## Hinckley & Bosworth Borough Council Interested Party Reference Number: 20039546

Deadline 3 Submission:
Response to Written Representation Comments

Application by Tritax Symmetry (Hinckley) Limited for an Order Granting Development Consent for the Hinckley National Rail Freight Interchange

(ref. TR050007)

Above extract from HGV Management Strategy, Figure 4.

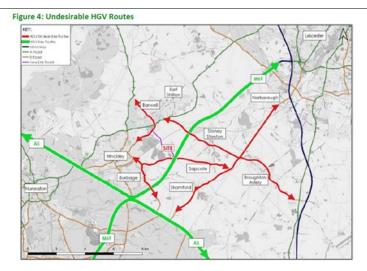
route. This implies that the traffic assessment is therefore incorrect, and these HGVs will be using other routes, and more information is needed to assess the local impact of HGV movements. The Council also has concerns about how the enforcement of the HGV strategy will be secured and undertaken.

The Council interprets the applicant's verbal response at ISH2 that this is a mistake, and that HGVs are meant to use the Link road, the B4468 and the A47 to and from the A5. However, this contradicts the text of the report which supports Figure 4. Para 3.11 describes the 'undesirable routes'; including 'c) To / from A5 west via: • Link Road, B4668, A47' – a footnote to this text states that 'Non-standard height HGVs which require more than 4.6m height clearance will be permitted to use the A47 to connect to the A5(W) at Dodwells as a means of avoiding the low bridge'.

In the Council's view it is inappropriate to depend on the A47 and B4468 as a core link from the west to a National Strategic Rail Freight Interchange;

these vehicles should use the A5 and M69 to and from the site. To do otherwise would mean that while the strategic case of the site depends on SRN access, this is severely compromised from two directions in the west and two North (J21 of the M1).

The HNRFI traffic should be required to use the A5 and M69, with local access HGV traffic only being permitted to use the link road to the west.
